Different carrier is using different steel spacer:

SHANG HUI BLIND COMPONENTS CO.,LTD

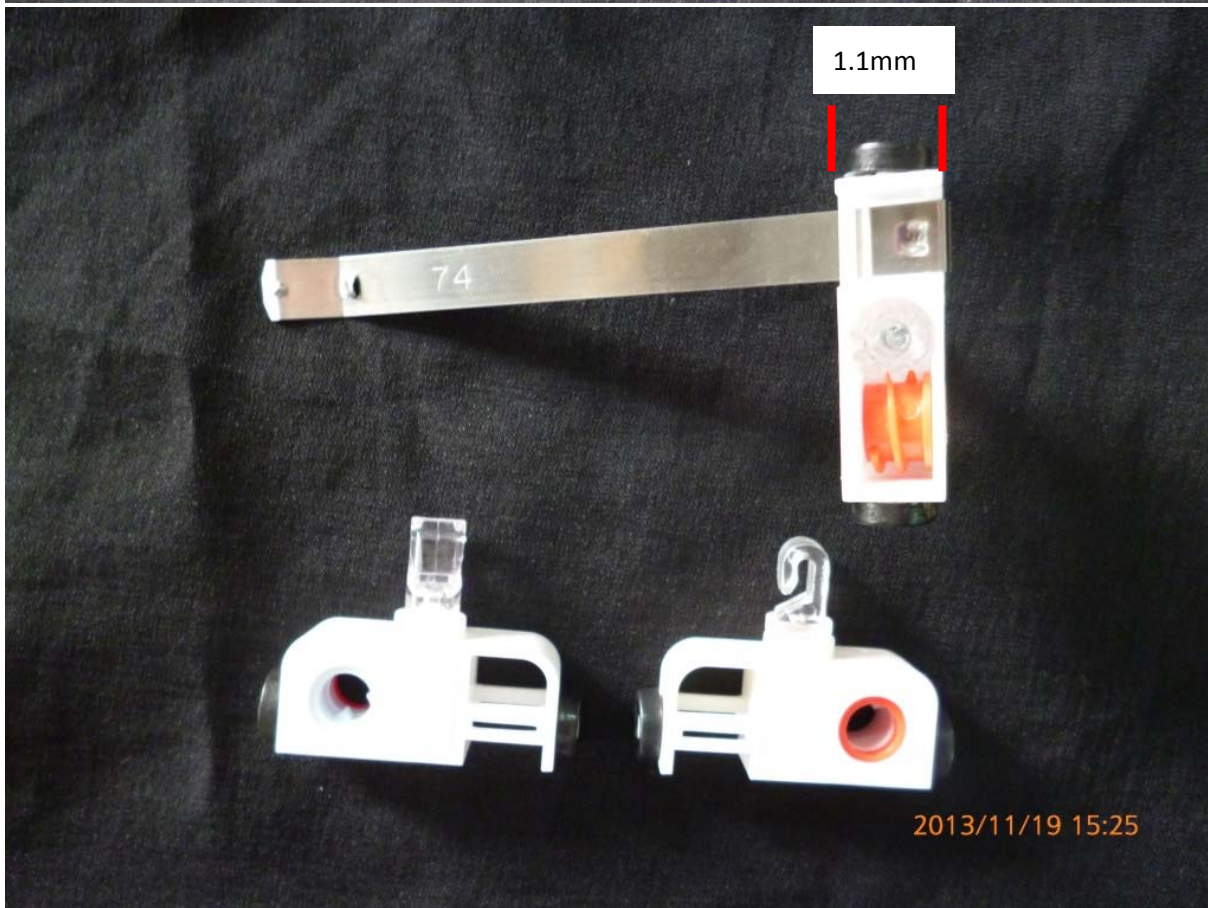
The width of traditional carrier is 1.1mm, so it must use 1.1mm bottom length of steel spacer.

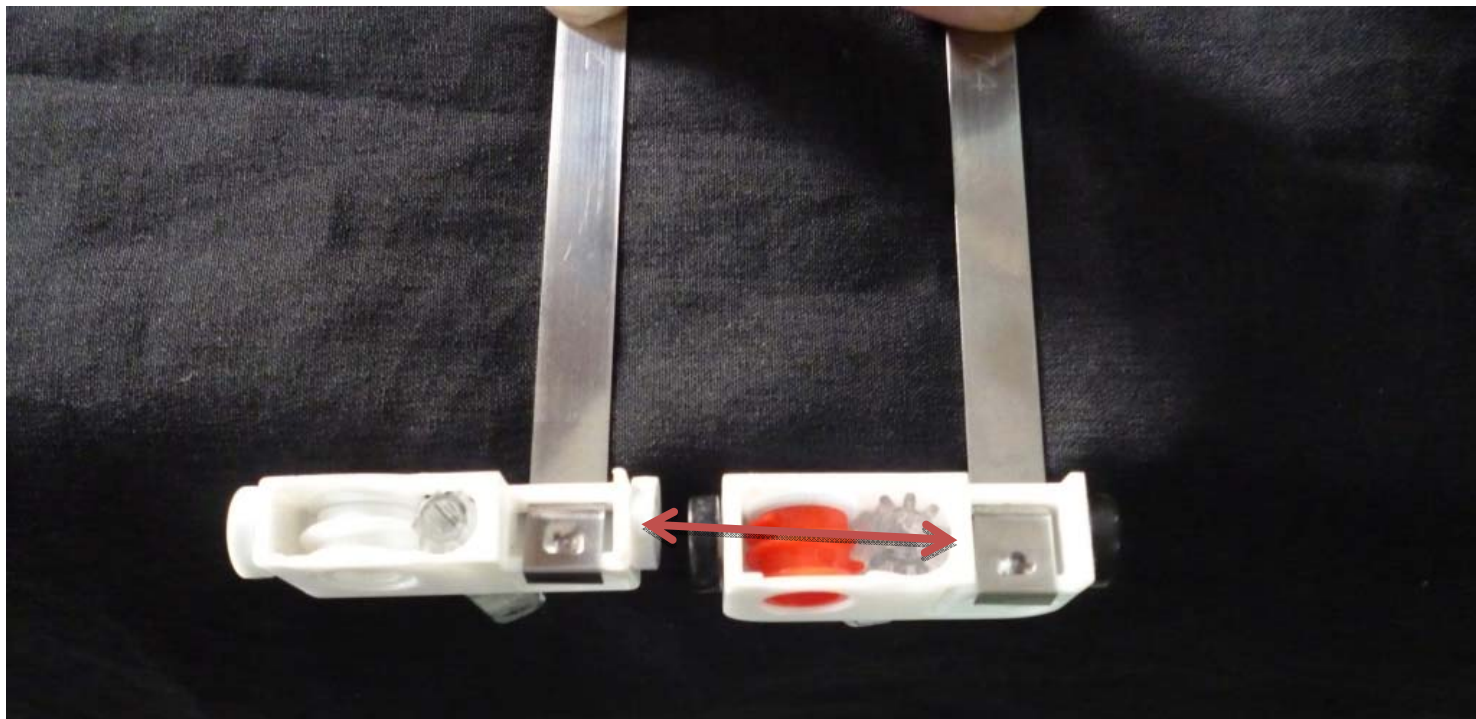
The carrier with removable hook is 0.8mm, so it must use 0.8mm bottom length of steel spacer.
